Well Name: LUCKY WOLF 31 FED COM	Well Location: T16S / R28E / SEC 31 / SENE /	County or Parish/State: EDDY / NM
Well Number: 2H	Type of Well: OIL WELL	Allottee or Tribe Name:
Lease Number: NMNM12110	Unit or CA Name: LUCKY WOLF 31 FED COM 2H	Unit or CA Number: NMNM127326
US Well Number: 300153744800S1	Well Status: Oil Well Shut In	Operator: EOG RESOURCES INCORPORATED

Notice of Intent

Type of Action Plug and Abandonment

EOG Resources, Inc. plans to plug and abandon this well as follows:

Lucky Wolf 31 Fed Com #2H Current

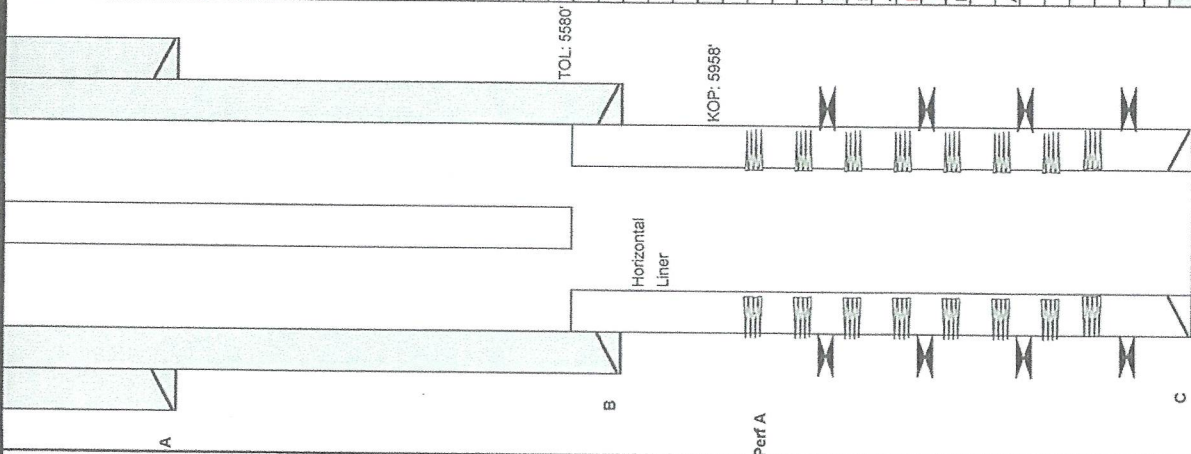
3. Perforate at 5826 ft. Spot a ~~25~~³⁰ sx Class C cement plug from 5826 ft – 5652 ft. WOC and tag. This will cover casing shoe. *WOC*
4. ~~Perforate~~^{Spot} at 5580 ft. Spot a 30 sx Class C cement plug from 5580 ft – 5395 ft. WOC and tag. This will cover top of liner. *(Sn/out)*

9. Spot a 25 sx Class C cement plug from 1035 ft – 883 ft. This will cover Queen top.
10. Perforate at 560 ft. Spot a ~~25~~²⁵ sx Class C cement plug from 560 ft – ~~408~~ ft. WOC and tag. This will cover Seven Rivers top and casing shoe. *surface*

11. ~~Spot a 25 sx Class C cement plug from 305 ft – 153 ft. This will cover Yates top.~~ *verify @ surface*
12. ~~Spot a 25 sx Class C cement plug from 50 ft up to surface. WOC and tag. Back fill as needed.~~
